U.S. Appln No. 09/976,925
Page 9

REMARKS/ARGUMENTS

**FIG. 1**

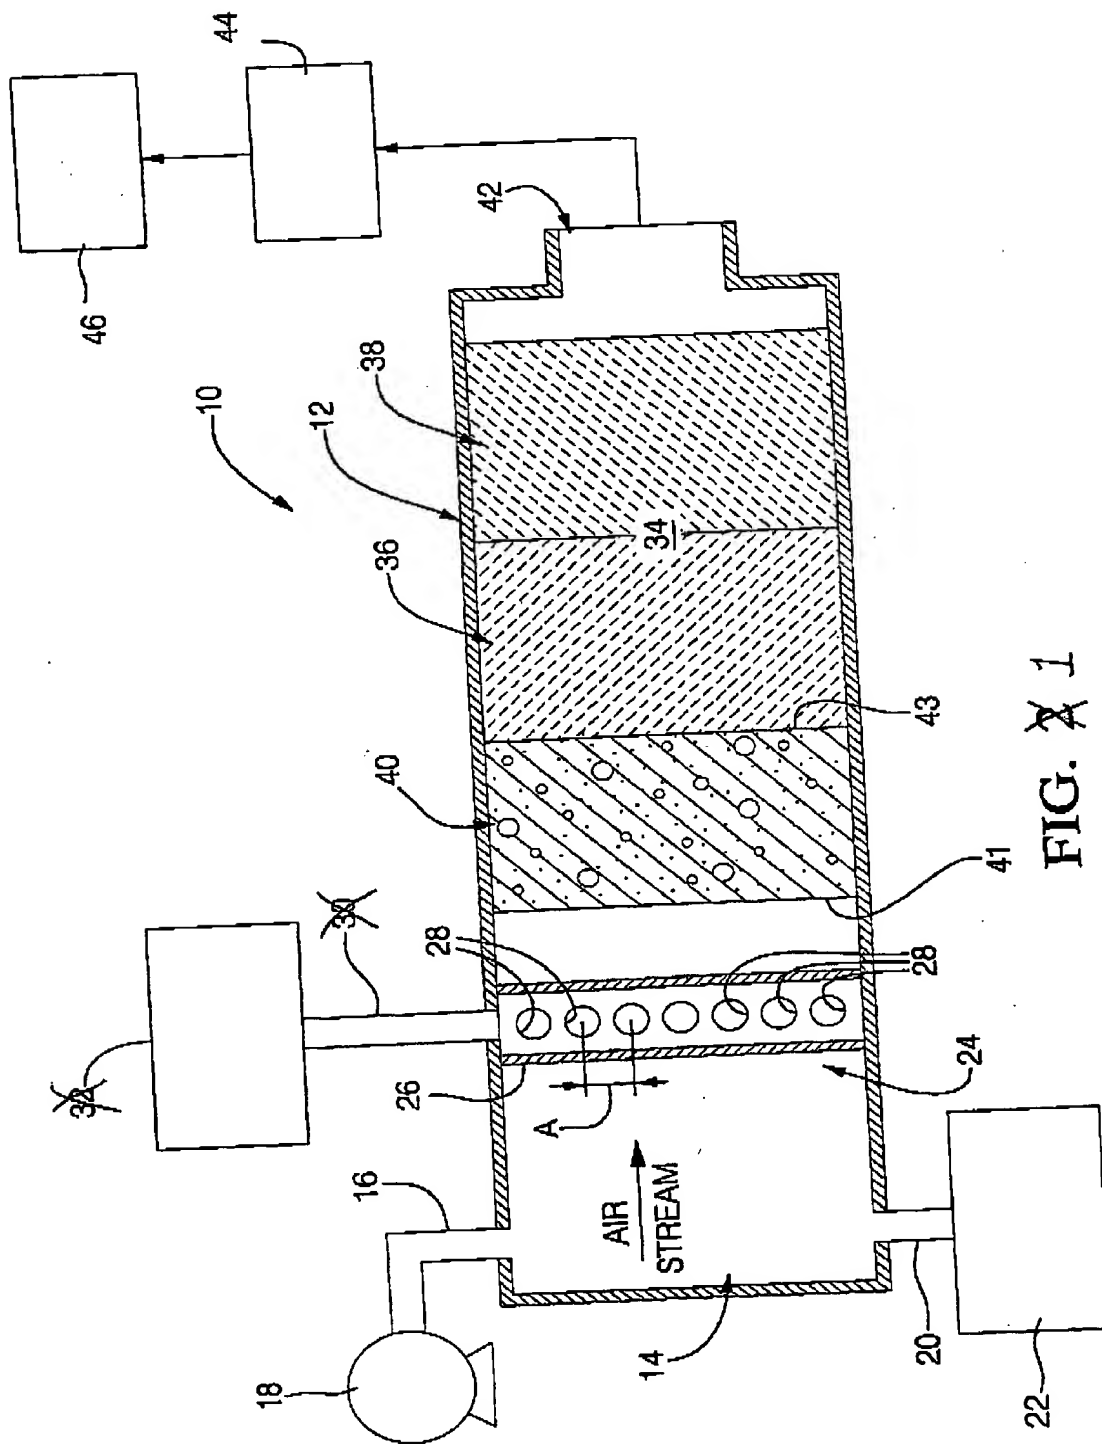
The drawings had been objected to as failing to comply with 37 CFR 1.84(p)(5) because they include the reference numerals "30" and "32" in both Figures 1 and 2. Applicants have amended Figures 1 and 2 to remove numerals 30 and 32. Withdrawal of the rejection is respectfully requested.

Applicants have also amended the drawings such that sheet 1/2 has changed "FIG. 2" to "FIG. 1".
